TITLE OF PROJECT: Wharton – Masonry Restoration to SW Exterior Stairs (FY24)

PROJECT NUMBER: CP23026

ADDENDUM NO: 01

OWNER:	Michigan State University 113 Student Services East Lansing, MI 48824
ARCHITECT:	Fishbeck 39500 MacKenzie Drive, Suite 100 Novi, MI 48377
DRAWING REVISION NO.:	A1
ISSUED HEREWITH:	
SPECIFICATION SECTIONS:	07 21 00
SHEETS:	DA-1, A-1, A-3, S-1, P-1, P-2
BIDS DUE:	January 24, 2024
This Addendum is issued to all Bid Set Holders, is a part of the Contract Documents, and modifies the previously issued Bidding Documents. Acknowledge receipt of this Addendum in the space provided on the Bid form; failure to do so may result in rejection of the Bid.

PARTIAL FIRST FLOOR DEMOLITION PLAN
SCALE: 1/8" = 1'-0"

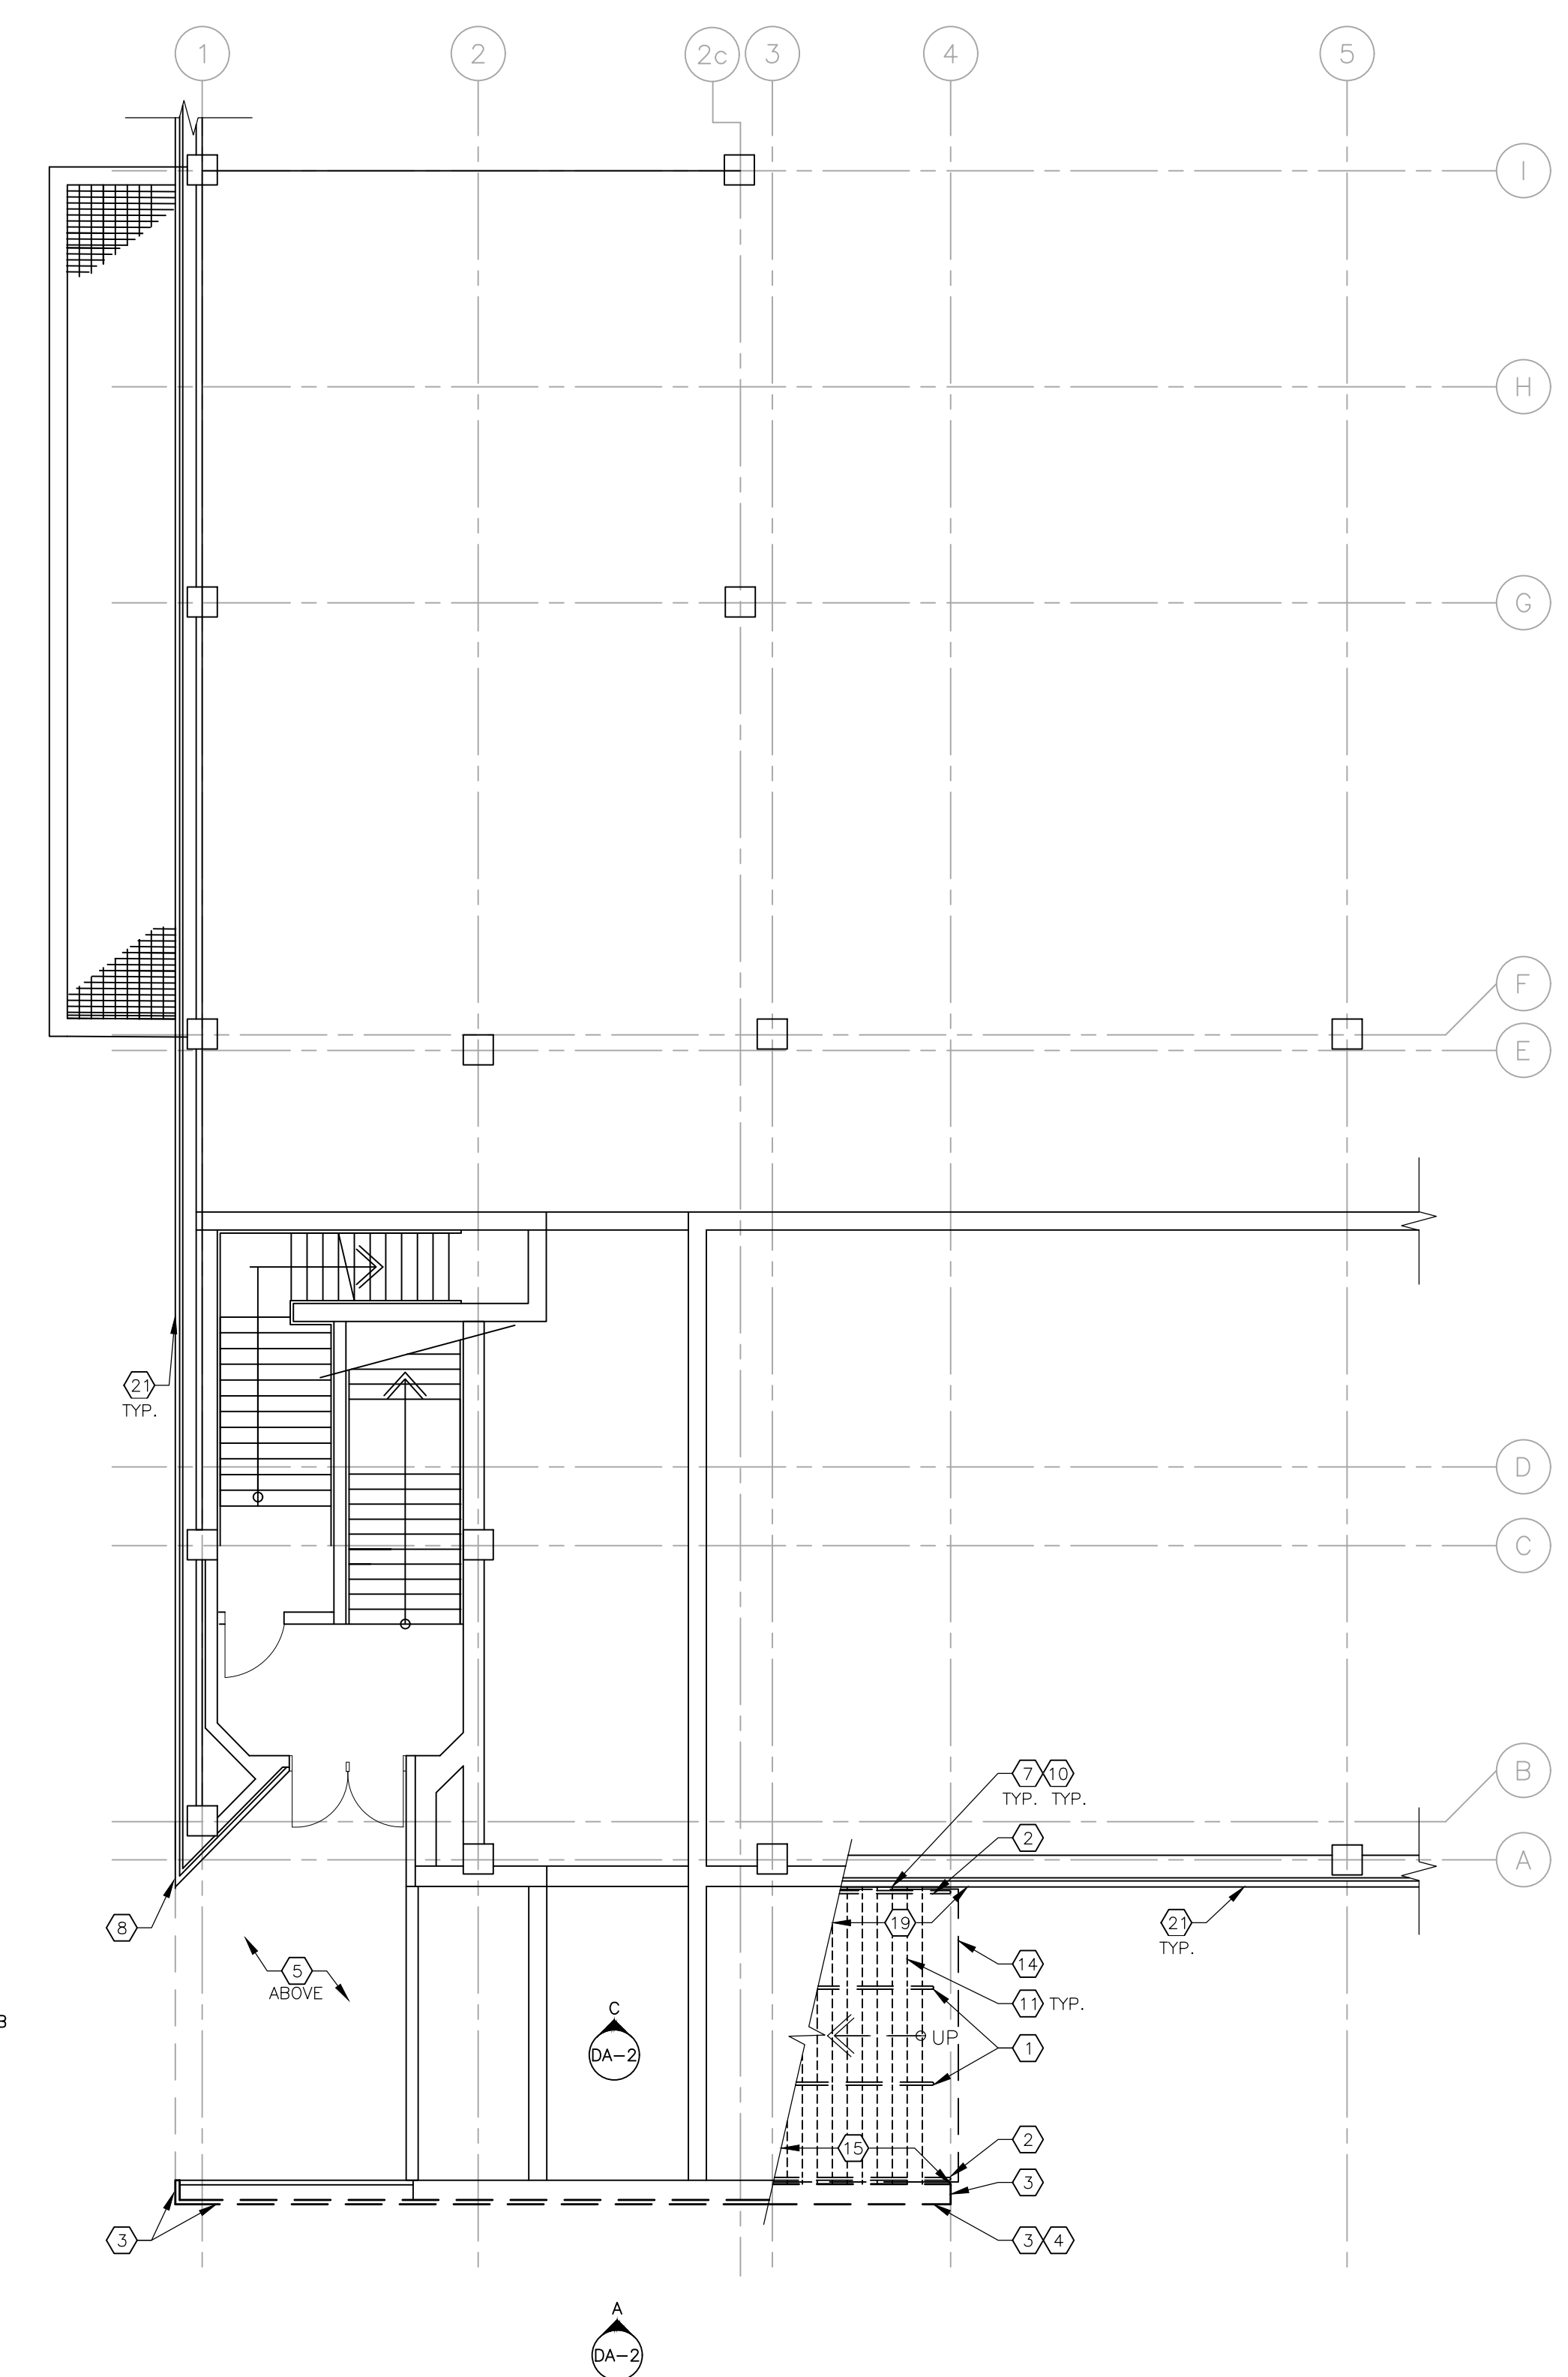
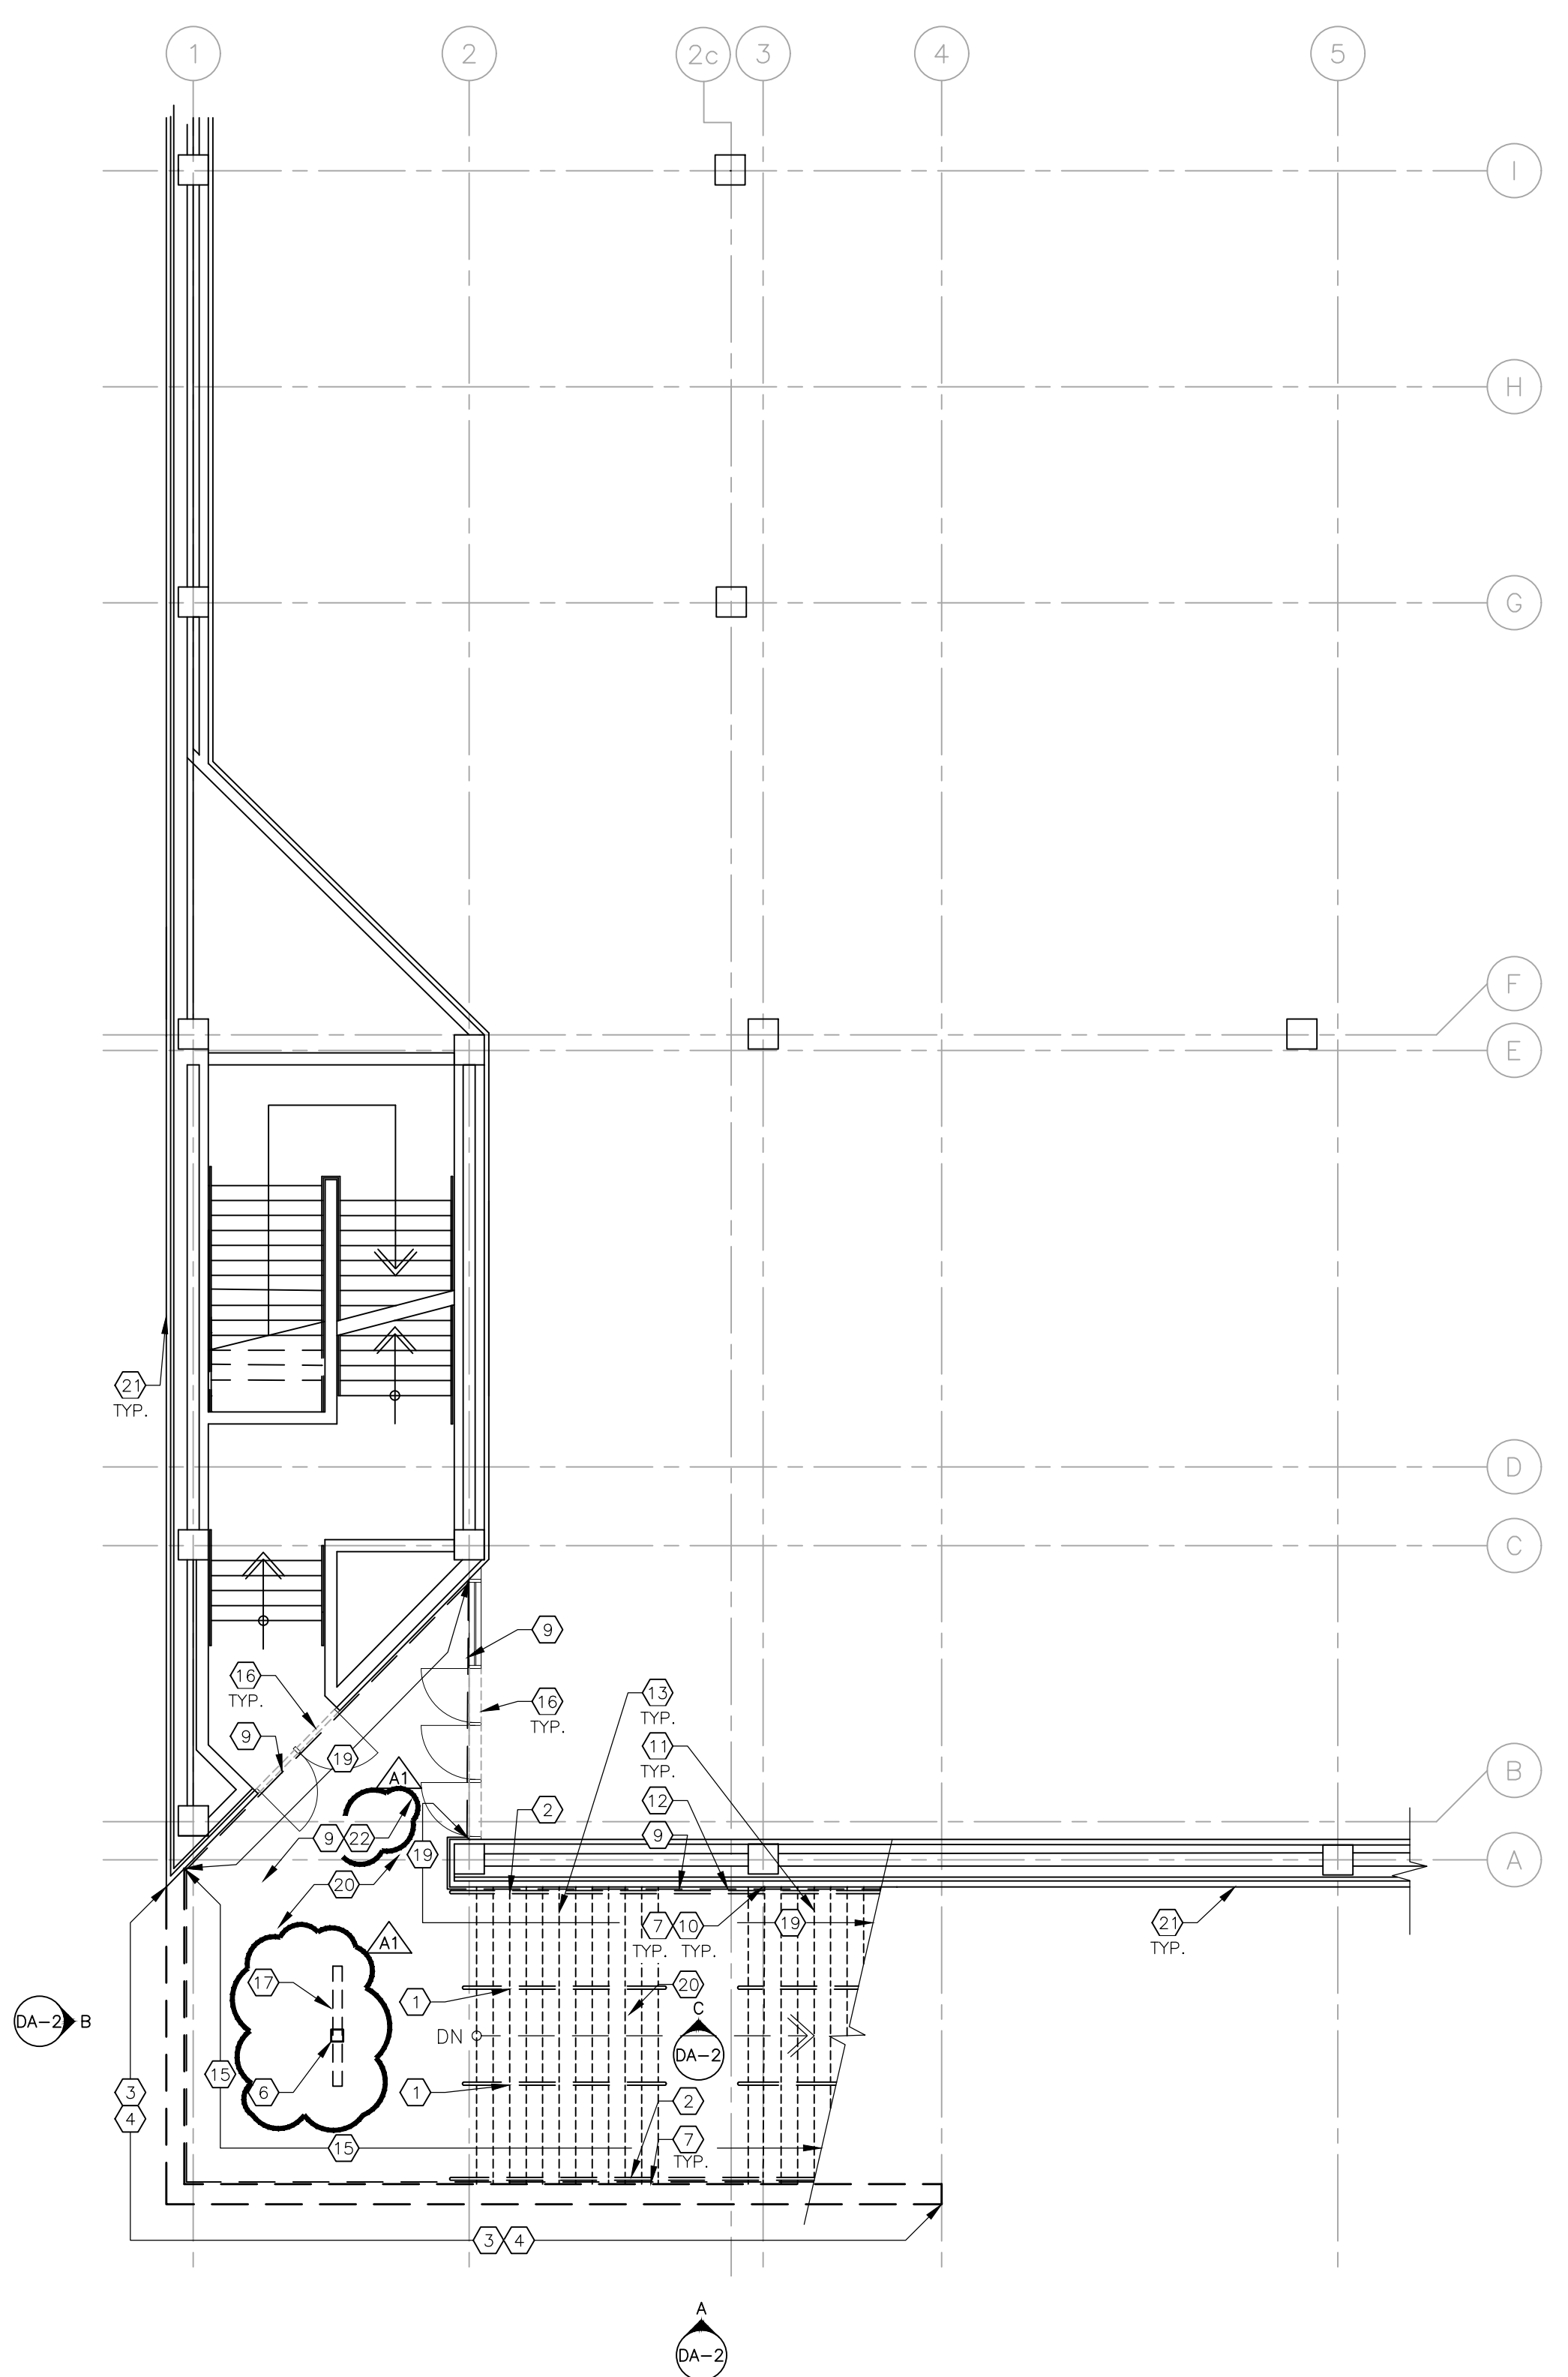
- A. Added new Specification Section 07 21 00.
- B. Clarified in architectural drawings the location of under slab insulation to be replaced.
- C. Clarified in architectural demolition drawings the location of under slab insulation to be removed.

- A. Revised architectural, structural, and plumbing drawings to remove two (2) AD-1, area drains, replace with one (1) TD-1, trench drain, and revise associated sanitary pipe. Revise Fixture Schedule to remove AD-1 and add TD-1.
- B. Clarified in structural drawings that if landing elevations or field conditions differ from what is illustrated within the drawings to notify engineer and to not proceed with drain installation.
- C. Clarified in architectural drawings the location of under slab insulation to be replaced.

22. REMOVED EX. SLAB INSULATION (INSULATION BELOW CONCRETE LANDING) IN ITS ENTIRETY, SUB-SLAB BELOW CONCRETE LANDING TO REMAIN.
